<b>Title of Change:</b>	Added comments and corrected typos in LV8907UWR2G datasheet and application note.	
<b>Effective date:</b>	1 July 2019	
<b>Contact information:</b>	Contact your local ON Semiconductor Sales Office or <Kei.Nagai@onsemi.com>	
<b>Type of notification:</b>	This Product Bulletin is for notification purposes only. ON Semiconductor will proceed with implementation of this change upon publication of this Product Bulletin.	
<b>Change Category:</b>	<input type="checkbox"/> Wafer Fab Change <input type="checkbox"/> Assembly Change <input checked="" type="checkbox"/> Test Change <input checked="" type="checkbox"/> Other <u>Added comments in datasheet and application note</u>	
<b>Change Sub-Category(s):</b>	<input type="checkbox"/> Manufacturing Site Addition <input type="checkbox"/> Material Change <input checked="" type="checkbox"/> Datasheet/Product Doc change <input type="checkbox"/> Manufacturing Site Transfer <input type="checkbox"/> Product specific change <input type="checkbox"/> Shipping/Packaging/Marking <input type="checkbox"/> Manufacturing Process Change <input type="checkbox"/> Other: _____

<b>Sites Affected:</b>	ON Semiconductor Sites: None	External Foundr

Figure 5. Example Waveform

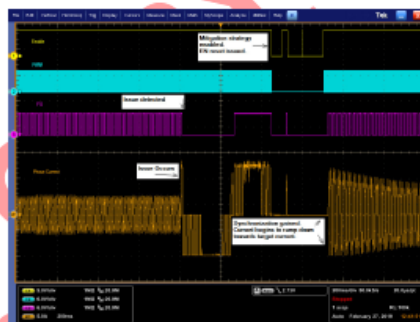
Figure 5 shows example waveform in the case that the commutation synchronization is lost. The coil current (Orange plot) shows abnormally high currents. FG pulse period changes drastically.

Figure 5 also shows example waveform of resynchronization by toggling EN pin. The EN pin should be set low immediately when incoherent FG pulse detected in an actual application.

The FG pulse must be monitored. When the loss of commutation synchronization is detected by the abnormal FG pulse train described above, LV8907UW must be restarted. By setting the rotation enable pin, EN, to a logical low state, the driver output is deactivated to halt the over current situation. After this deactivation, the pin EN should be set logical high to restart. The LV8907UW will enter its normal startup sequence and regain synchronization. To enable this resynchronization of LV8907UW, the register bit named FRREN must be set 0. (See [datasheet](#) for detail).

### 9. A metric prefix kilo must be lowercase.

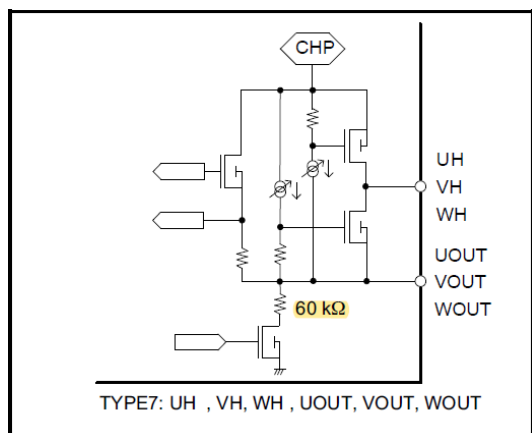
The charge pump circuit operates nominally at 52.1 **KHz**.  
A SSCG function is provided to add a spread-spectrum component for EMI reduction.
